**ATTACHMENT B
NRC STAFF RESPONSES TO THE LICENSING BOARD'S
INITIAL QUESTIONS REGARDING THE FEIS**

NRC STAFF RESPONSES TO THE LICENSING BOARD'S INITIAL QUESTIONS REGARDING THE FEIS

Figure 1
Worst-Case 24-hour Total PM₁₀ Concentrations (Background plus *Highest* Concentrations from Emissions Related to the Proposed Action) during (a) Land Clearing Phase and (b) Building Construction Phase

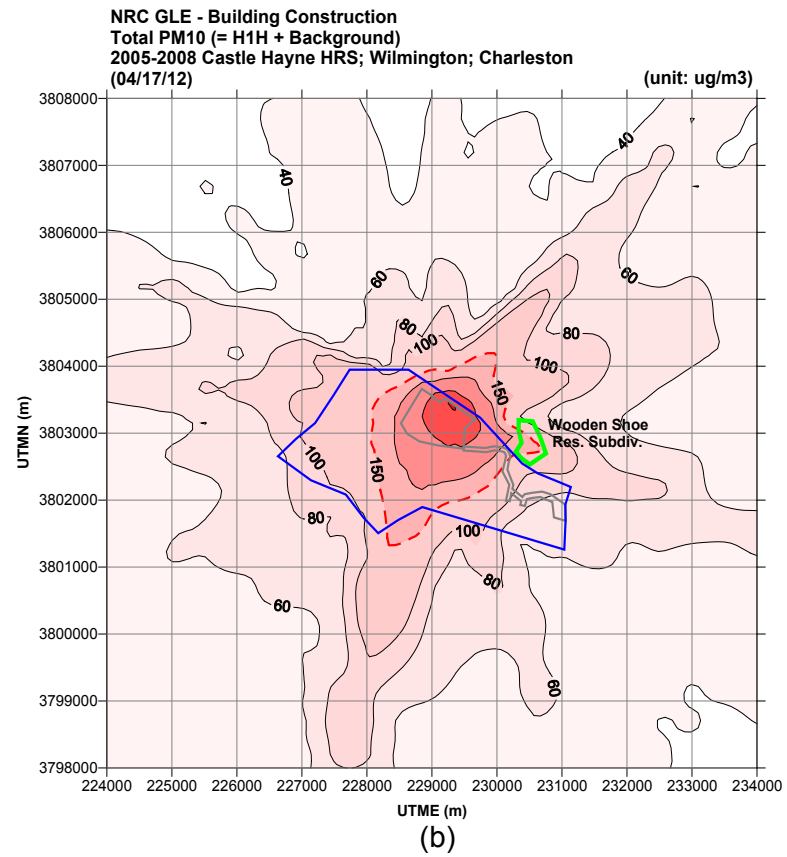
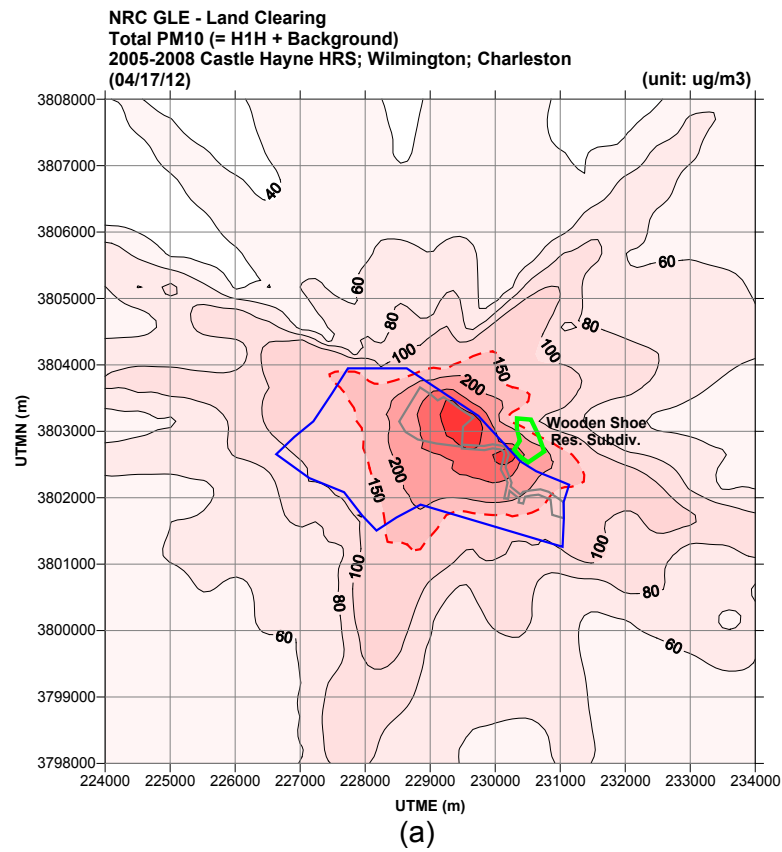
FEIS Question No. 22: *Twenty-four hour concentrations of particulate matter are predicted to exceed air quality standards during preconstruction and construction phases. How widespread will this decrease in air quality be? What effects are expected on the residents of the Wooden Shoe residential subdivision? (EIS 4-13)*

Response No. 22 (Y.-S. Chang): The worst-case concentrations of 24-hour total (background plus contribution from the proposed GLE Facility) particulate matter (PM), including coarse particulate matter (PM₁₀) and fine particles (PM_{2.5}), associated with land clearing activities are predicted to exceed the respective National Ambient Air Quality Standards (NAAQS) at the proximate northern boundary of the Wilmington Site near the proposed GLE Facility (less than 50 meters [164 feet] from the boundary). Comparably high PM concentrations are also predicted at the northern site boundary near the Wooden Shoe residential subdivision, close to which the North access road would be located (about 25 meters [82 feet] from the boundary). The high PM concentrations at the Wooden Shoe residential subdivision would result primarily from fugitive dust emissions during vehicle traffic on unpaved roads during the land clearing phase. On average, up to 2 and 3 days per year are predicted to have NAAQS exceedances for PM₁₀ and PM_{2.5}, respectively, at residences adjacent to the North access road in the Wooden Shoe subdivision during the land clearing phase. As shown in Figure 1a (following this response), worst-case 24-hour total PM₁₀ concentrations (background plus *highest* concentrations from emissions related to the proposed action) over the NAAQS level during land clearing could reach approximately 0.6 mile (1.0 kilometer) from the Wilmington Site boundary near the proposed GLE Facility and about 0.3 mile (0.5 kilometer) from the northern site boundary near the Wooden Shoe residential subdivision. The concentration contours in Figure 1 represent the highest concentrations at each receptor over the modeling period, not an instantaneous 24-hour average for any single day. The worst-case total 24-hour concentration contours for PM_{2.5} are wider than for PM₁₀, but distances to the 24-hour NAAQS level are similar to that for PM₁₀.

During building construction, predicted 24-hour total PM concentrations would exceed their respective NAAQS beyond the site boundary, mostly to the north of the proposed GLE Facility. However, an average of less than one exceedance per year is anticipated to occur in the Wooden Shoe residential subdivision because the subdivision is about 0.8 mile (1.3 kilometer) east of the proposed GLE Facility site, just off the prevailing southwesterly winds, and because the North access road would be paved at the conclusion of the land clearing phase. As shown in Figure 1b (following this response), the worst-case 24-hour total concentration contours for PM₁₀ during building construction are smaller than during land clearing, but the distances to the NAAQS level are similar. The same is true for PM_{2.5} during land clearing and building construction.
